RE: **Lot 28 Block 8 Volcano Cliffs Unit 5 SAD 227**  
**6208 Marigold Ct. NW**  
**Grading and Drainage Plan**  
**Engineers Stamp Date: 9/20/2021 (E10D111)**  
**Pad Certification Date: 5/13/2022**  
**CO Certification Date: 3/14/2023**

Based upon the information provided in your submittal received 3/17/2023, this plan for Certificate of Occupancy cannot be approved until the following comment are addressed.

ENGINEER'S SEAL  9/20/21 DAVID SOULE P.E. #14522	6208 MARIGOLD	DRAWN BY: WCVJ DATE: 9-17-21 210210085-LAYOUT-9-18-21
	GRADING AND DRAINAGE PLAN  1606 CENTRAL AVENUE SE SUITE 201 ALBUQUERQUE, NM 87106 (505) 872-0999	SHEET # — JOB # 210210085

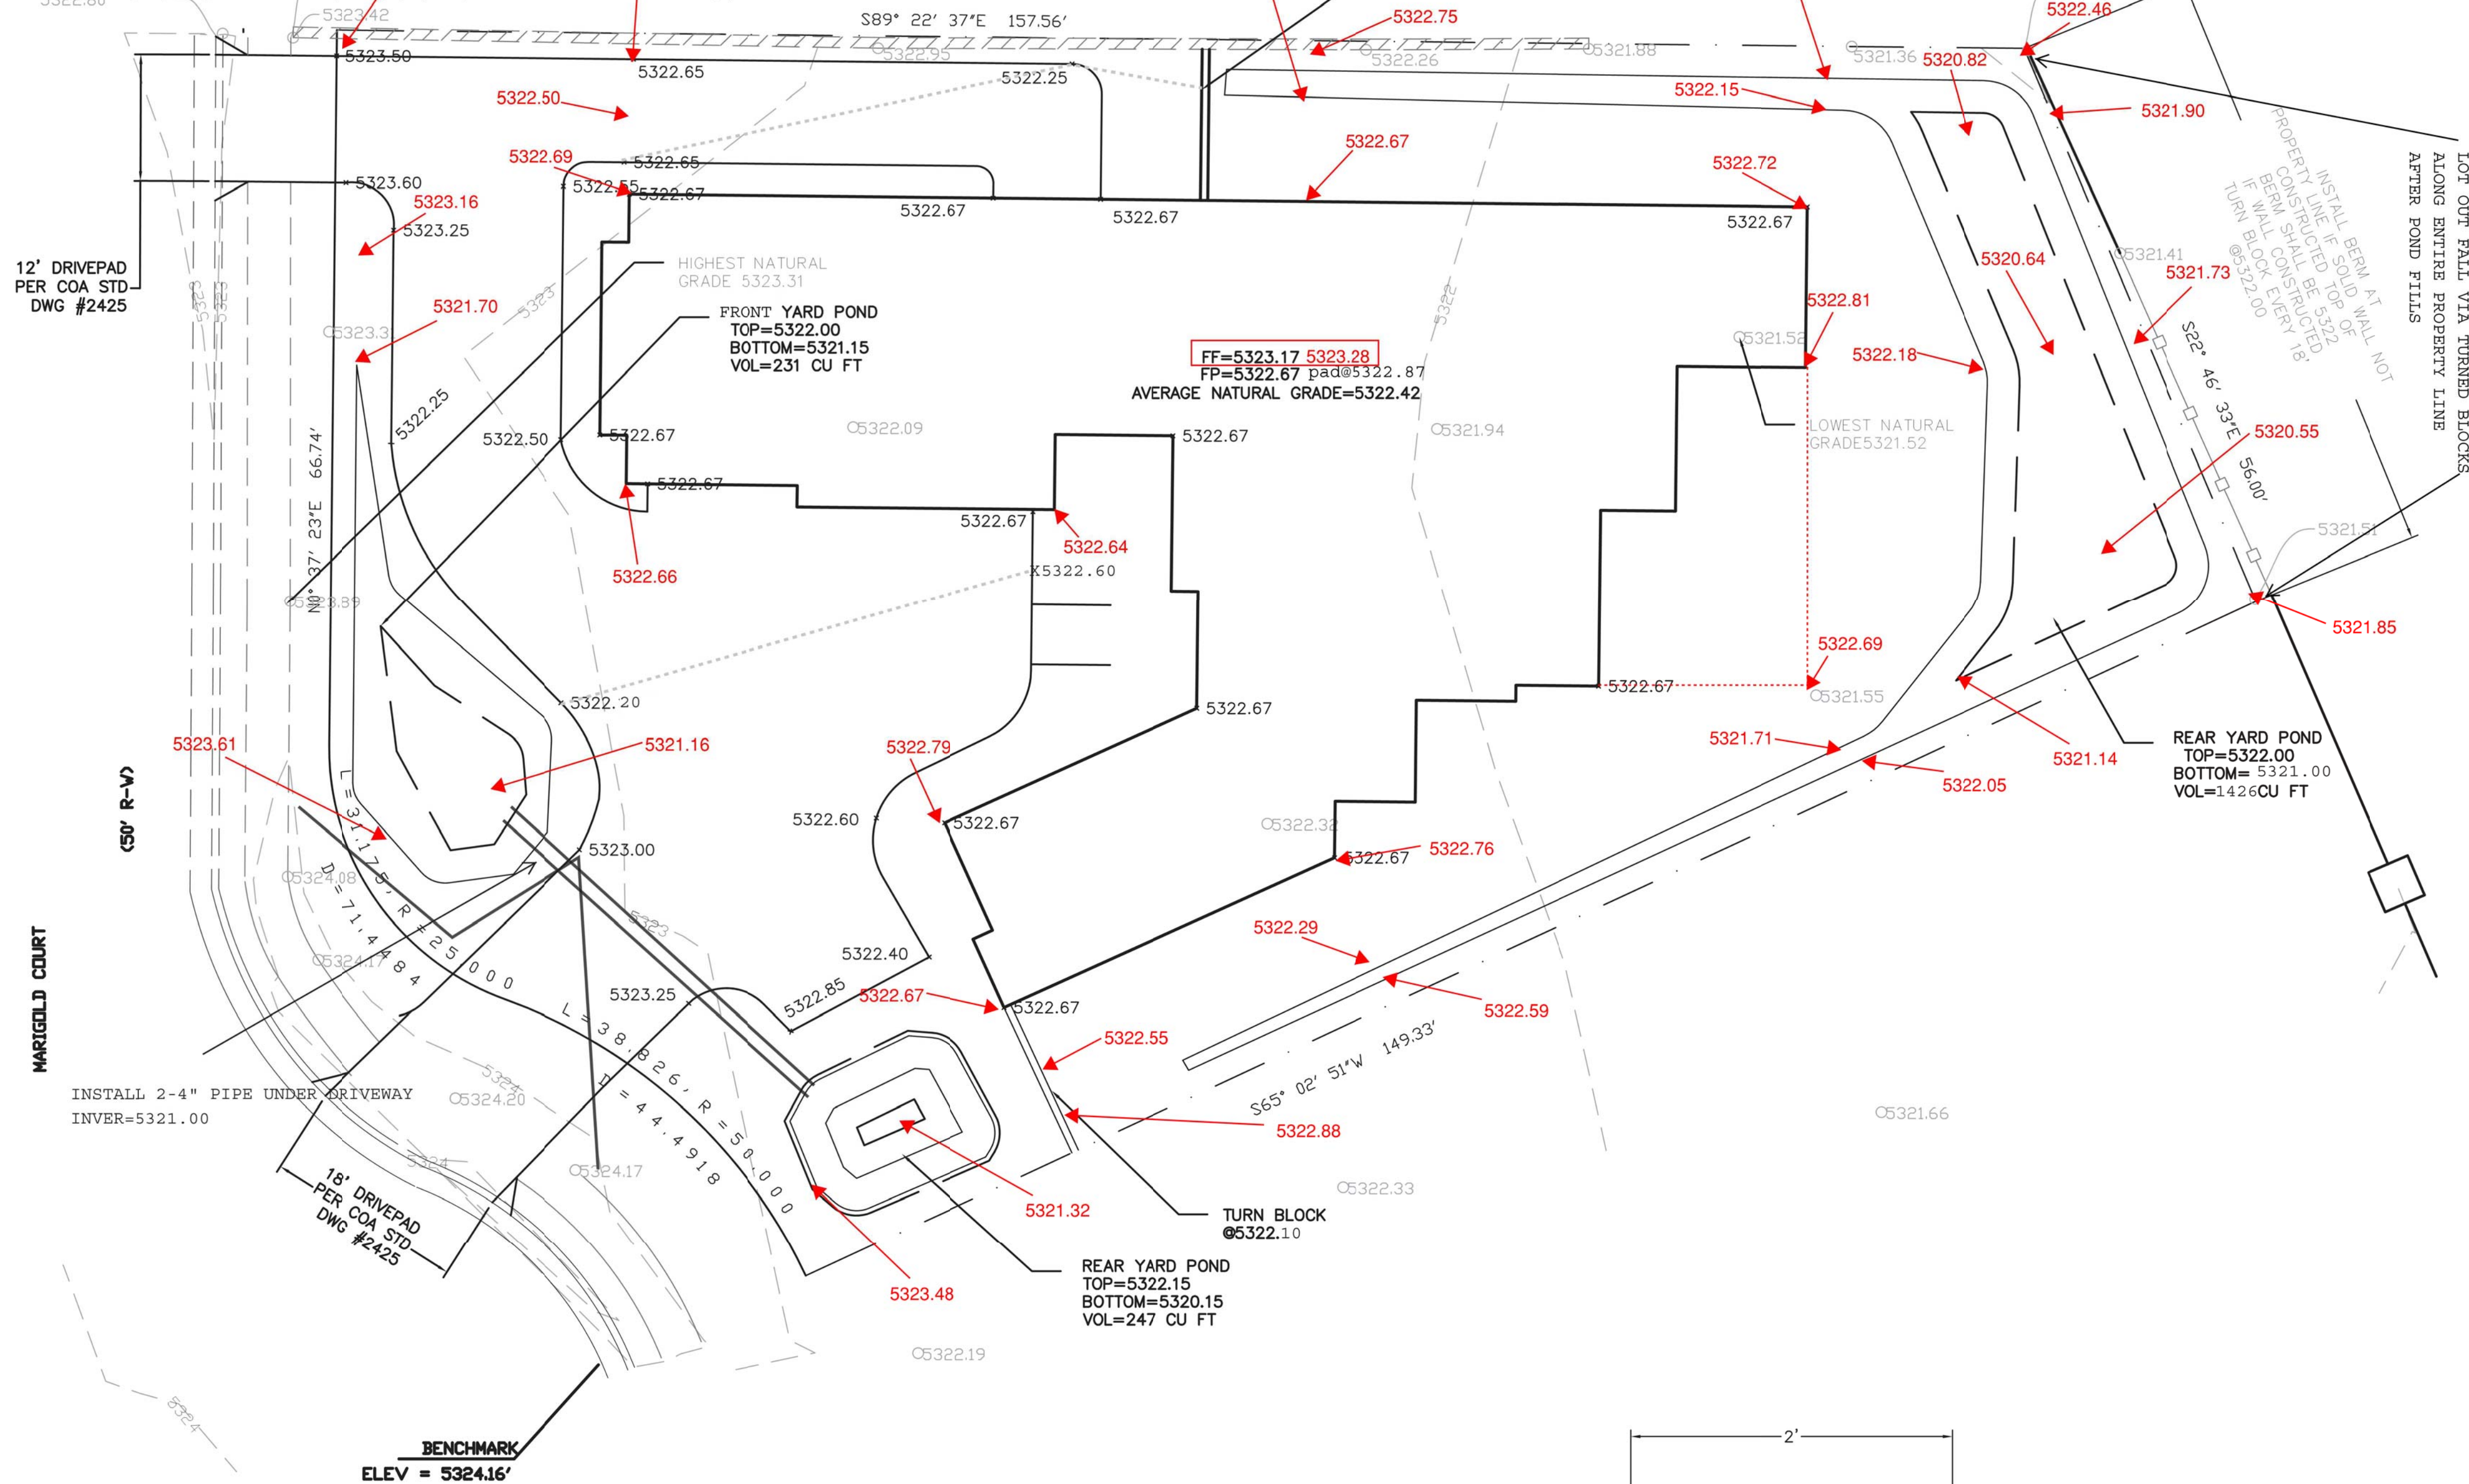
- The port-a-potty needs to be removed.
- Ponds must be filled with some type of gravel.
- Concrete drive pad must be in place.
